In Reply Refer To: HSSD/B-183

Name of system:	Nu-Cable Systems – Use of Plastic or Steel Sockets Use of driven steel sockets
Type of system:	Cable Barrier
Test Level:	NCHRP Report 350 TL-3 and TL-4
Testing conducted by:	Holmes Solutions of New Zealand and Texas Transportation Institute
Date of request:	July 25, 2006

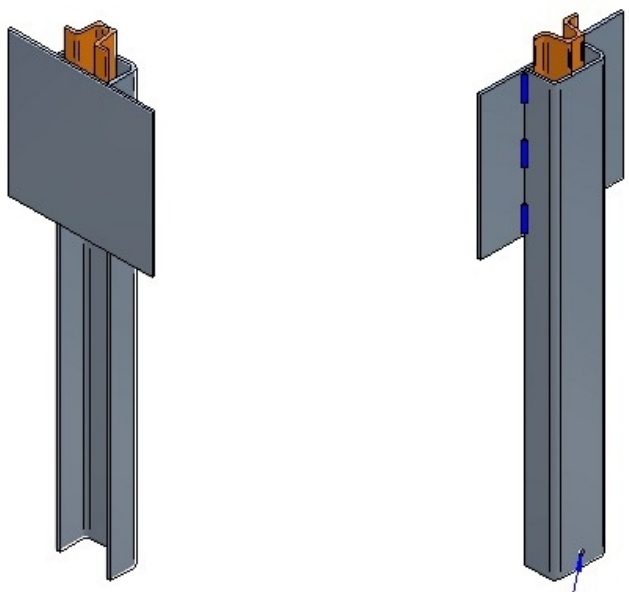
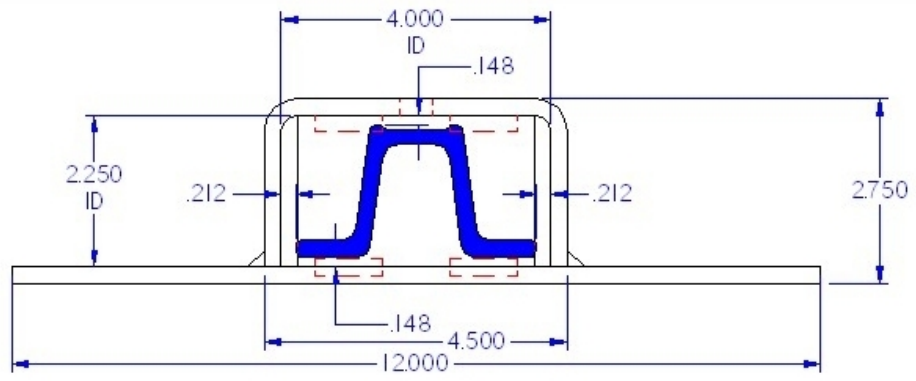
You also requested the use of driven steel socket sleeves for 4-pound-per-foot u-channel posts, as shown in the enclosed drawing. Informal vehicle testing in standard soil showed no perceptible movement of the socket.

- 1) Posts mounted in plastic socket sleeves encased in a rebar fortified concrete foundation,
- 2) Posts mounted in steel socket sleeves encased in a rebar fortified concrete foundation,
- 3) Posts mounted in driven socket sleeves with soil plates.
